**CAMECO RESOURCES
CROW BUTTE OPERATION**

Annual Report of Changes, Tests, or Experiments
License No. SUA-1534
Docket No. 40-8943

Crow Butte Resources, Inc. (CBR) d/b/a Cameco Resources – Crow Butte Operation (CBO) is providing this annual report summarizing the changes, tests or experiments made under License Condition 9.4 of SUA-1534 during calendar year 2016. This report is made in accordance with the reporting requirements contained in License Condition 9.4 (E).

Figure 3.2-1 removed and replaced
per SERP 16-04

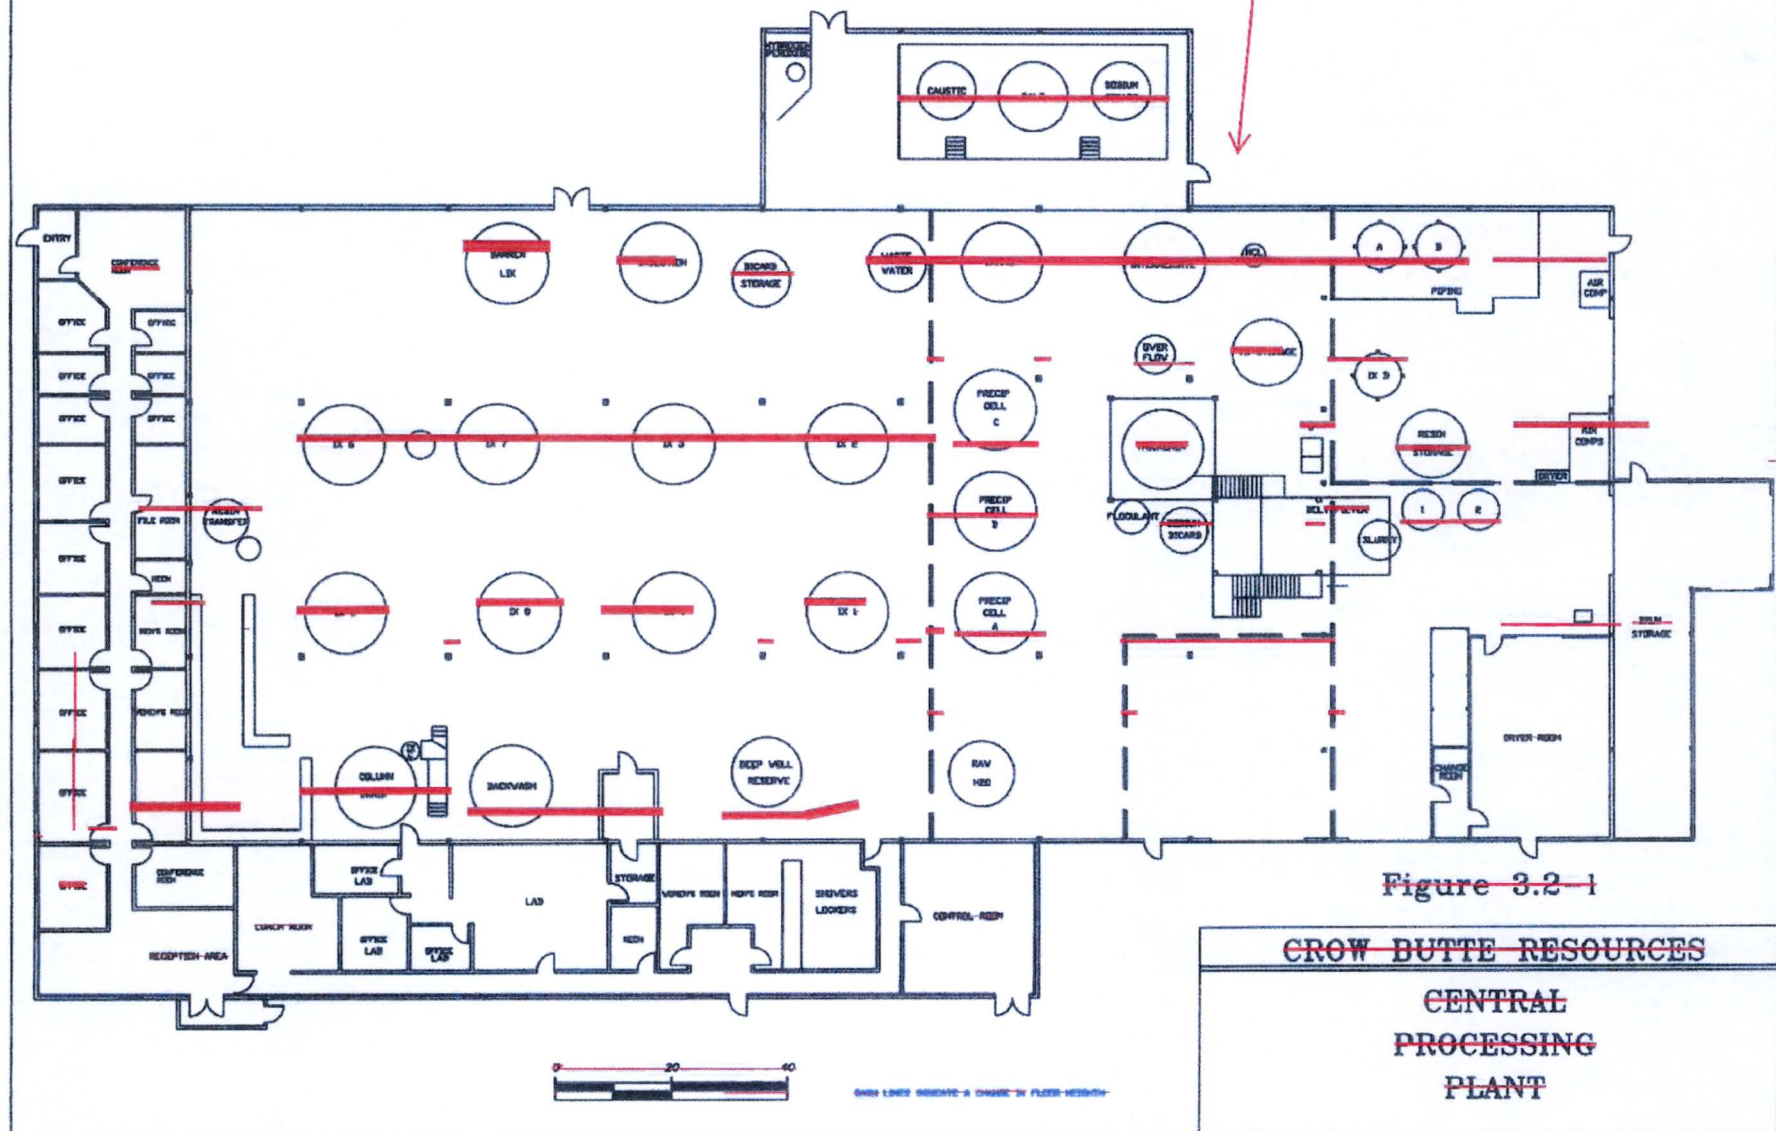
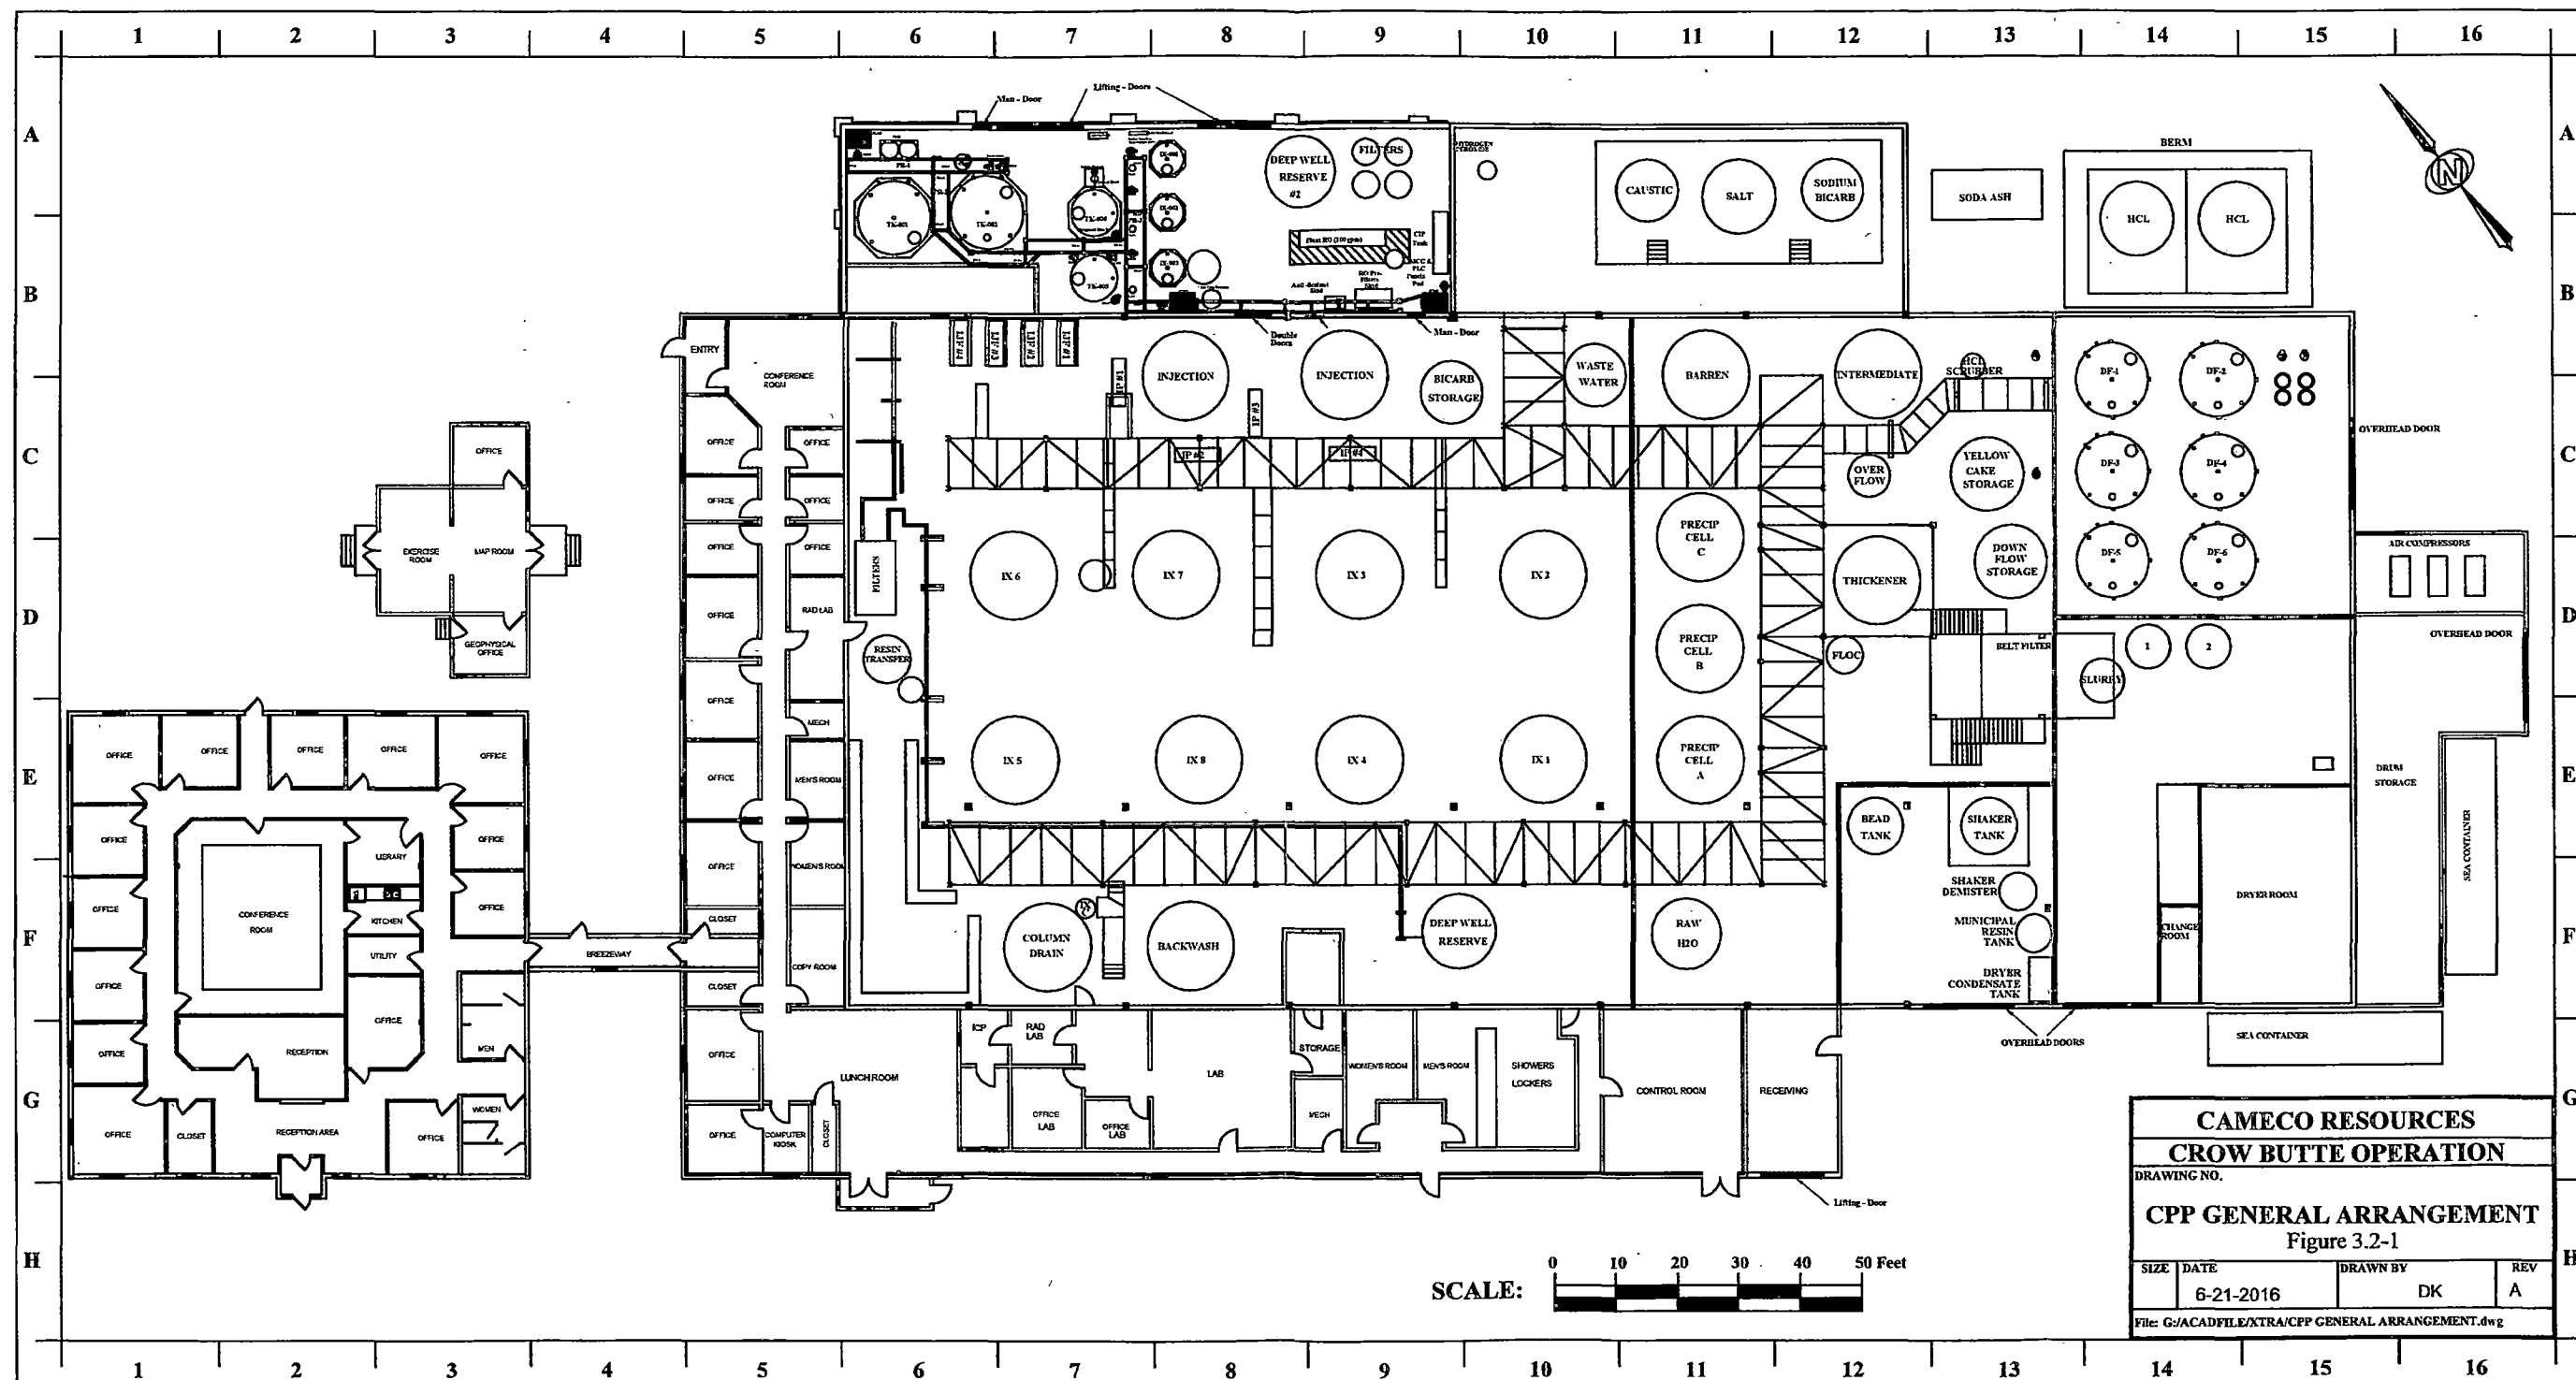
Section 3.2.1, Process Plant Equipment – Revised Figure 3.2-1 to add the Pond Water Treatment circuit and the Downflow IX circuit. The Pond Water Treatment circuit and Downflow IX circuit are described in the NRC staff's review in Section 3.2.3 of the SER. The revision to this figure does not change the intent of the NRC staff's review.
